## DART SERVICE INSTRUCTION

TO AMEND INSTALLATION INSTRUCTIONS IIN-D206-570 REV. C & INSTALLATION DRAWING D206-570 REV. D REF. TCCA STC: SH90-19 REF. FAA STC: SH810NE

FIGURE 1. TEE FITTING RELOCATION

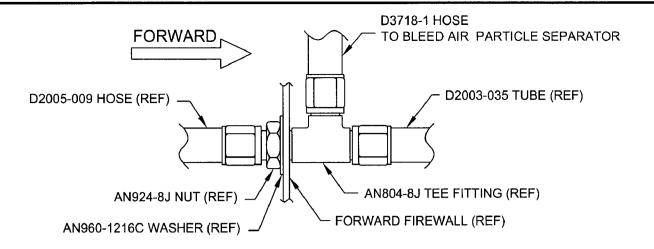
- 1. The existing AN804-8J tee fitting can be moved to the forward side of the forward firewall as shown in Figure 1.
- 2. The D3718-1 hose can be installed off the AN804-8J tee fitting and connected to the bleed air particle separator as shown in Figure 1.

## FIGURE 2. D206-570-049 VALVE ASSEMBLY (VIEW LOOKING INBOARD AT RH SIDE)

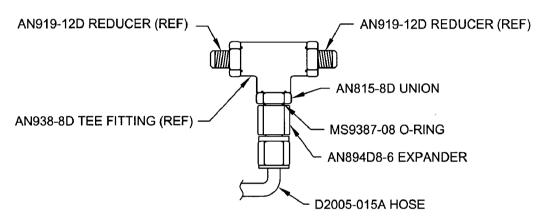
- 5. The AN815-8D union, MS9387-08 O-ring and AN894D8-6 expander can be installed between the existing AN938-8D tee fitting on the RH side of the D206-570-049 valve assembly and the new D2005-015A hose as shown in Figure 2.
